PLANNING COMMISSION MEETING

RE: White Lake Retail Building-9197 Highland Road - Preliminary Site Plan Review- 2nd Review

Amended Site Plan / Planned Business Review for White Lake Charter Township, Michigan

Re: Site Plan Approval
9197 Highland Rd.

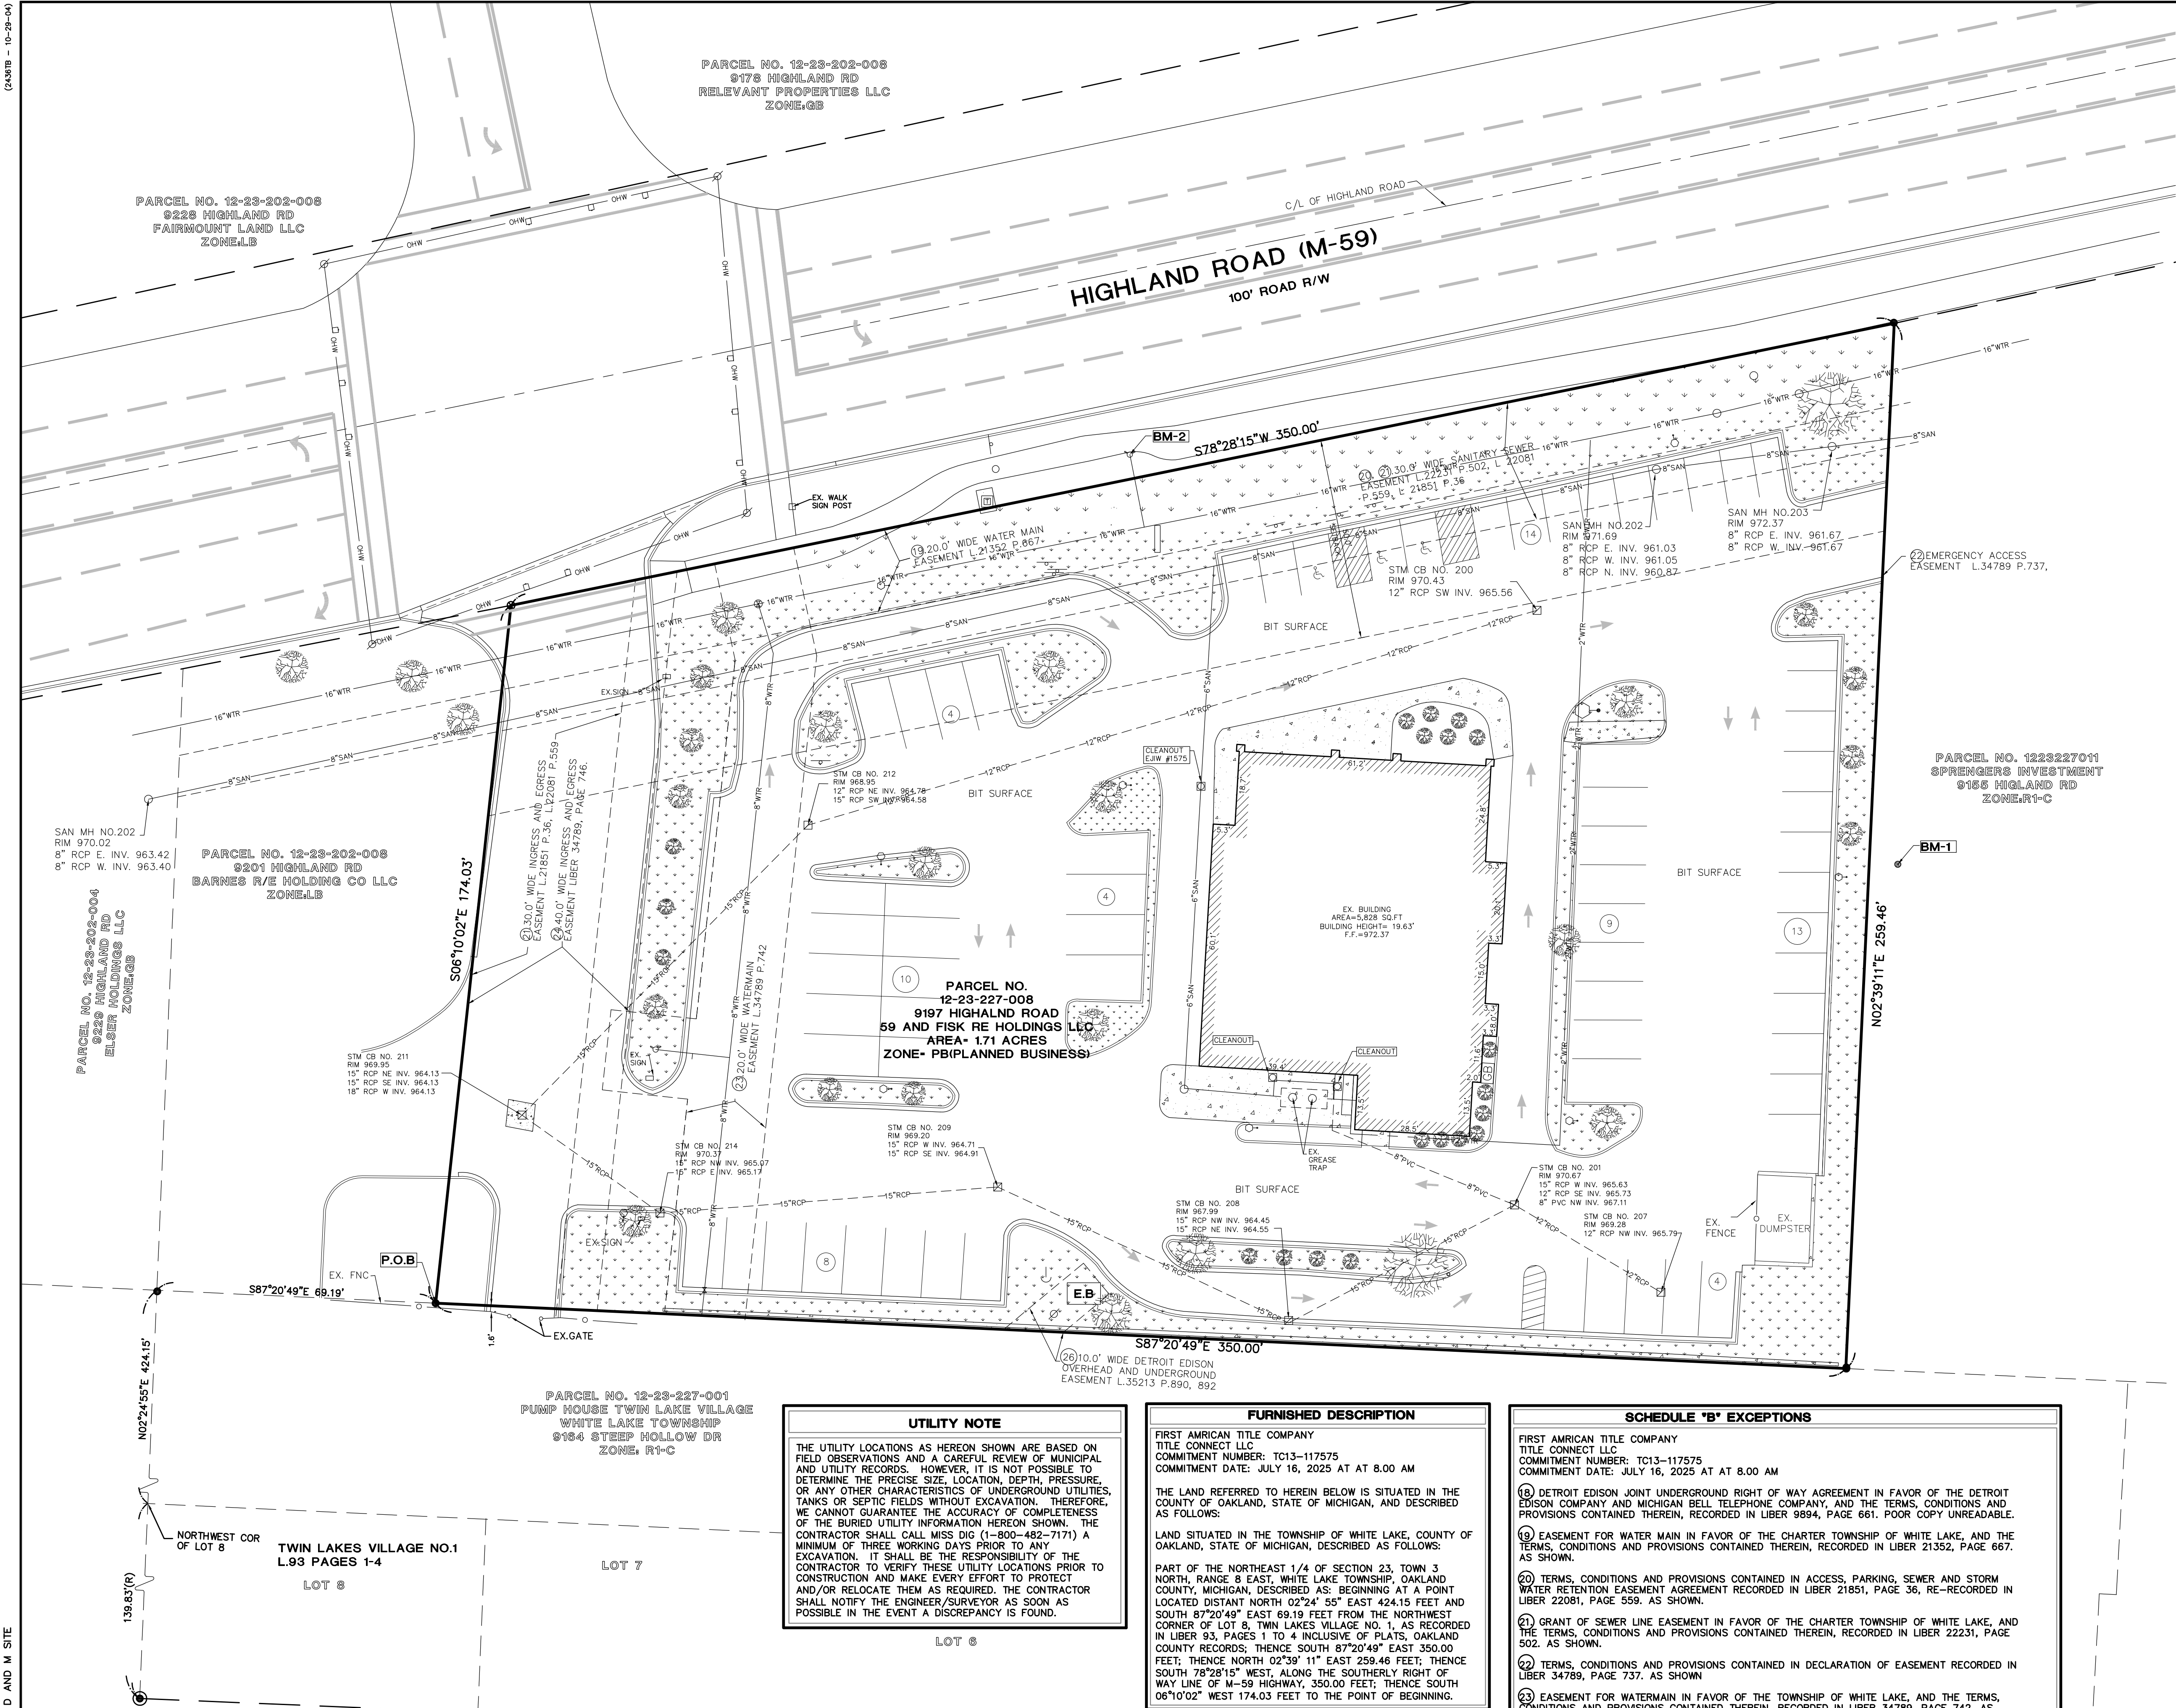
- The plan violates the max footcandle limit of 0.2 at residentially zoned lot lines to the south. This property do not appear to be used as residential.
- The existing parking lot permitter light poles appear to violate the max height allowance of 16 feet when within 25 feet of a lot line.
- The site's general average footcandle is 1.5 fc. The standard states the average footcandle measurement should be .5 fc.

- 1) *The site's general average footcandle measurement exceeds the .5 fc standard. Planning Commission will need to determine if this is acceptable.*
- 2) *Footcandle measurements at residential lot lines and exiting light pole height do not meet current standards. If proposed to remain, the Planning Commission will need to consider a waiver.*

10. Site footcandle averages should be added to the plan per Section 5.18.G.viii.
Our plan Sheet AS-3 shows the Photometric Plan.
11. Footcandle measurements at residential lot lines and existing pole height do not meet.....
The existing site pole lights, location and heights are to remain unchanged. The two new light poles we are providing east of the New Canopy shall meet the ordinance and be 20' high. We do meet the requirements for fc levels per the ordinance at adjacent property lines. See AS-3.
